MODIFICATION REQUEST:

***Chris O'Brien Lifehouse at RPA, Camperdown
(MP10_0036 MOD 2)***

- Installation of three double-sided way finding signage structures

Director-General's
Environmental Assessment Report
Section 75W of the
Environmental Planning and Assessment Act 1979

Figure 3: Proposed Signage Details

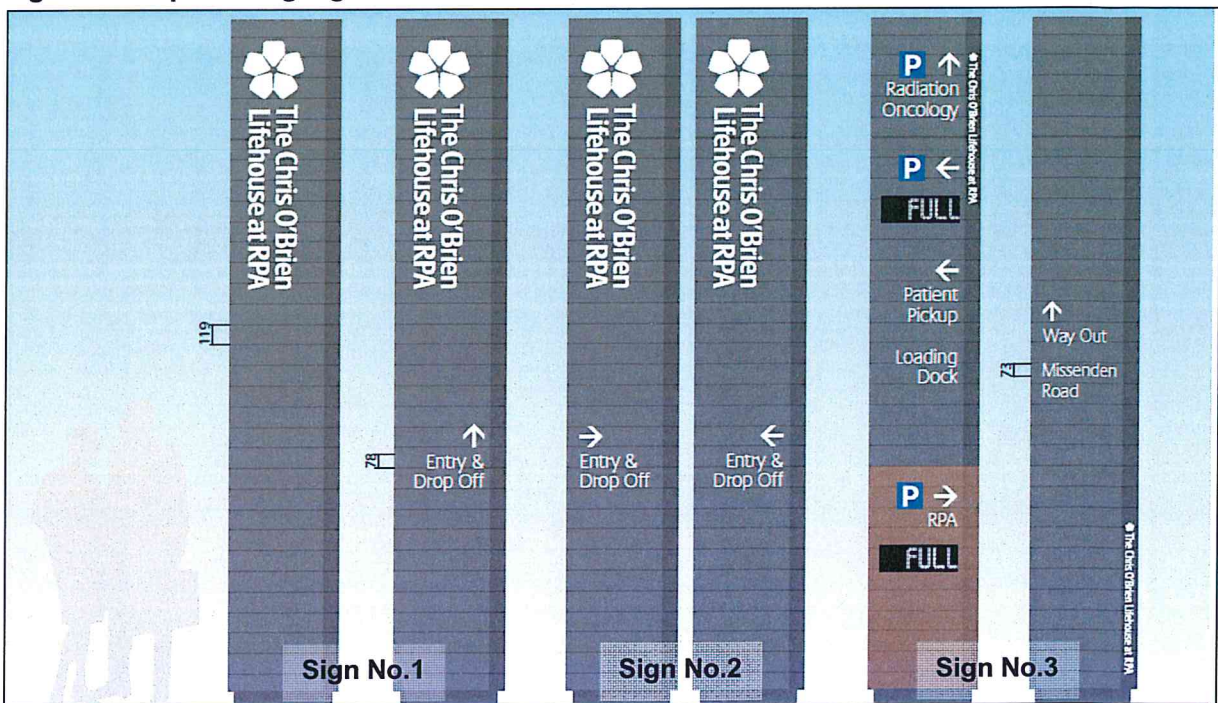
Council raised no objection to the proposed signage structures, but did recommend that the height of the signs be reduced to three metres to lessen their visual impact. Council's submission also provided recommended conditions.

In response to council's recommendation to consider a reduction in the height of the signage structures, the proponent submitted additional information to support and justify their proposed design, advising that the design rationale for the height and width of the signs responds to the location of the building's Salisbury Road entrance (pedestrian and vehicle) and existing traffic conditions of Missenden Road. Specifically, the proposed notes:

The department is satisfied that the proposed height and scale of the signs are satisfactory and respond appropriately to the Lifehouse development (see **Figure 5**). In this regard, the scale of the signage structures will complement the two to three storey glass façade/undercroft (ground floor to level 2) addressing the Missenden Road and Salisbury Road streetscapes.

the form and function of the health facility, assisting patients, relatives and friends to navigate the facility and surrounding RPA precinct. Further, the department considers that reducing the height of the signage structures to three metres would not significantly reduce any potential visual impacts that may arise from their installation as proposed at four metres. The scale and design of the proposed signage structures are a response to the existing setting, form and function of the Lifehouse development and surrounding RPA precinct, to ensure that wayfinding information provided is conveyed in a clear and effective manner.

Figure 4: Signage Structure No.3

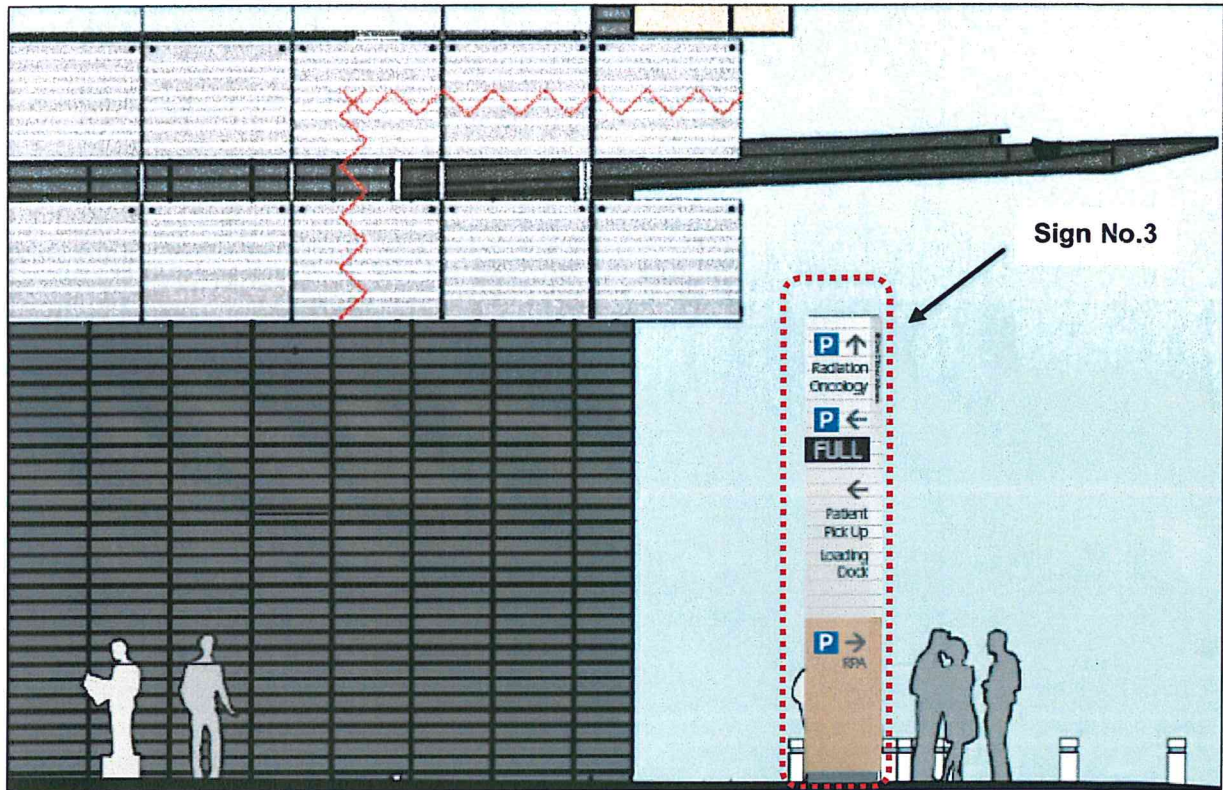
- signage structure no.3 is complex due to the content of information (see **Figure 4**)
- the signs require considered vertical spacing to distinguish between identification and information to avoid a blur of compressed information

Sign 3 is proposed to provide information regarding the car parking for the Lifehouse building, RPA hospital car parking and directional information for parking associated with the Radiation Oncology building. Digital information displayed on the subject sign provides information in relation to the capacity of the car parking areas for the RPA hospital and Lifehouse building, which is an innovative feature that will assist in the management of the hospital's operations.
